June 30, 1980

B.3.2.1
WY 80-100

United States Nuclear Regulatory Commission
Washington, D.C. 20555

Subject: Request for Additional Information on Adequacy of Station
Electric Distribution System Voltages

FIG. 1
 ONE LINE DIAGRAM-125-DC BUSES
 AND 120V-AC VITAL BUSES
 MAINE YANKEE ATOMIC POWER COMPANY

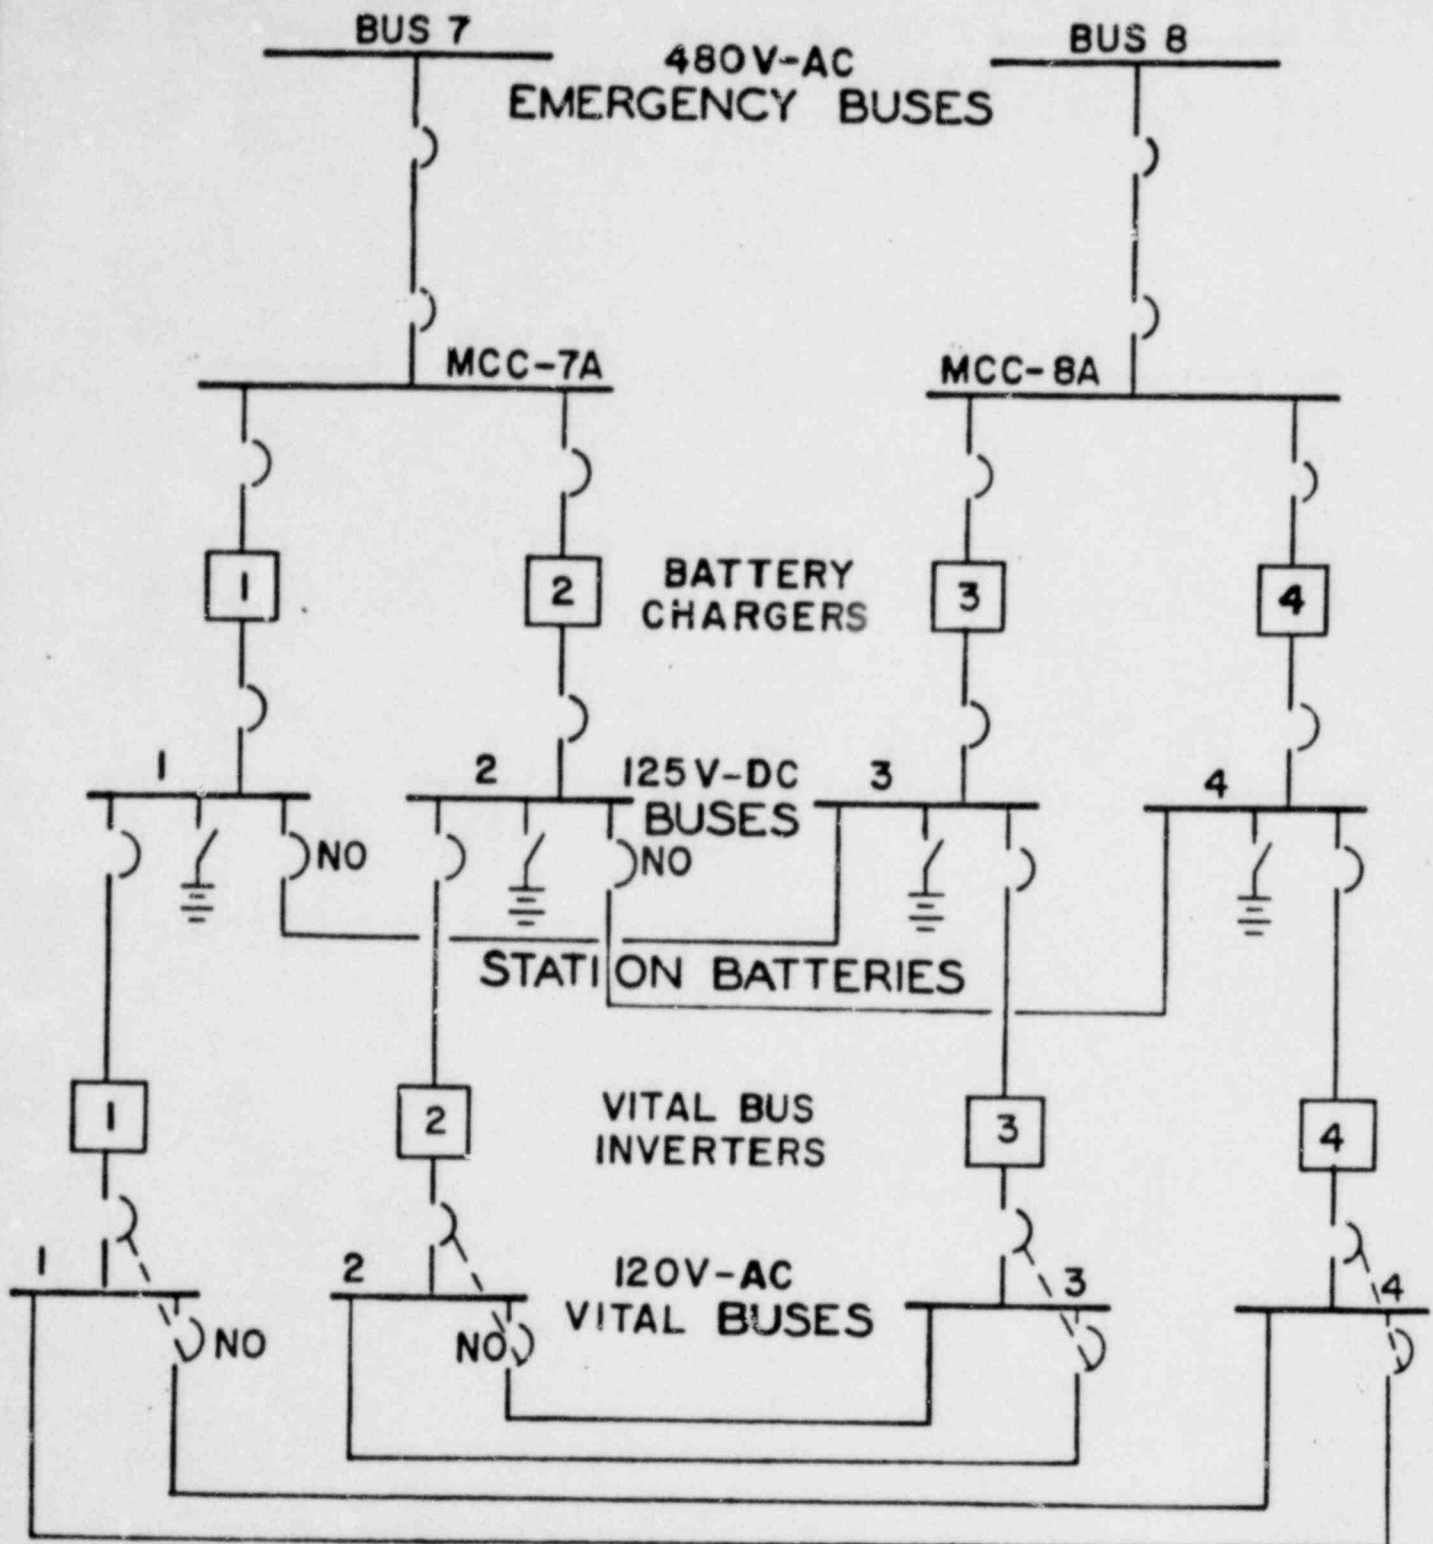
Supply the calculated voltages for all low voltage ac (less than 480 V) Class 1E buses (including alternate sources) for each analyzed case. Do these systems supply any instruments or control circuits as required by GDC 13? If so, is all the equipment capable of sustaining the analyzed voltages without blowing of fuses, overheating, etc., and without affecting the equipment's ability to perform the required function?

The four Class 1E 120 volt vital instrument buses are shown in the attached Figure 1. Each bus is fed directly from a 120 volt inverter. The inverter voltage is regulated to 120 V ac $\pm 2\%$.

Each inverter is normally powered by the station battery - battery charger. The battery charger requires 460 volts $\pm 10\%$ to operate successfully. Reference (4) demonstrates that adequate voltage is supplied by the station auxiliary power system to operate the battery chargers. If the battery chargers are not operable the inverters are supplied by the station batteries. There are no other ties from the station auxiliary power system to the Class 1E 120 volt buses. There are no other buses that supply 120 volt ac safety related instrument and control loads.
